UNITED STATES PATENT AND TRADEMARK OFFICE

APPLICATION NO.	FILING DATE	FIRST NAMED INVENTOR	ATTORNEY DOCKET NO.	CONFIRMATION NO.
10/511,434	10/25/2004	Karl Robert Schafer	WI.1674PCT-US	4578

Office Action Summary	Application No.		Applicant(s)	
	10/511,434		SCHAFFER, KARL ROBERT	
	Examiner		Art Unit	
	Leslie J. Evanisko		2854

DETAILED ACTION

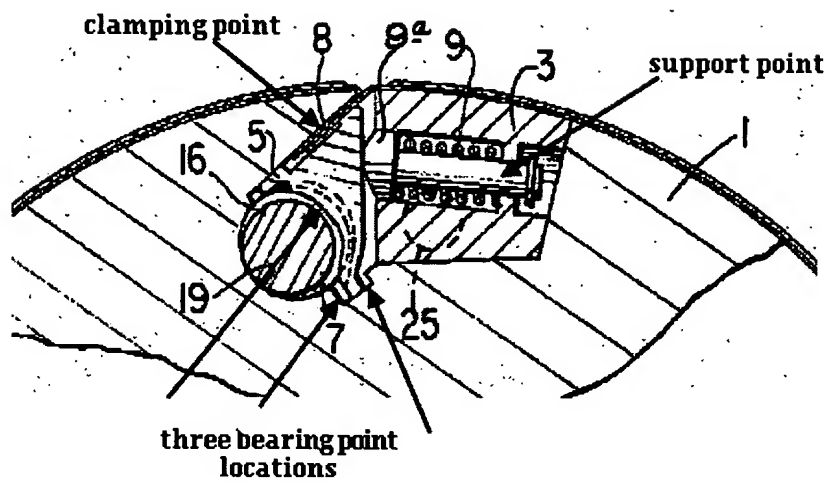
With respect to claim 51, note each of the bearing point(s) shown in the marked-up copy of Figure 6 of Luehrs can broadly be considered to be “adjacent” a bottom surface of the groove as recited.

Luehrs teach a trailing end leg clamping means to clamp either a plate or blanket arrangement 10, 11 including a clamping element pivotable lever 4, 5 supported for pivotable movement in a bearing point (see marked up Figure 6 above) opposite the opening of the groove, a spring 9, 9a engageable with the pivotable lever and engageable (at least indirectly) with one of the first and second walls at a support point, the pivotable lever holding the trailing end leg in a clamping point against one of the first and second opening walls opposite the support point, the spring 9, 9a providing a counterforce holding the pivotable lever in the bearing point. Again attention is invited to the above set forth rejection of claim 39 and the marked up copy of Figure 6 attached above. In view of this teaching, it would have been obvious to one of ordinary skill in the art to use the clamping arrangement shown in Luehrs as the clamping structure in both the forme cylinder and transfer cylinder of Holm as it would simply require the obvious substitution of one known clamping structure for another to provide a simplified clamping mechanism for securing the plate ends.
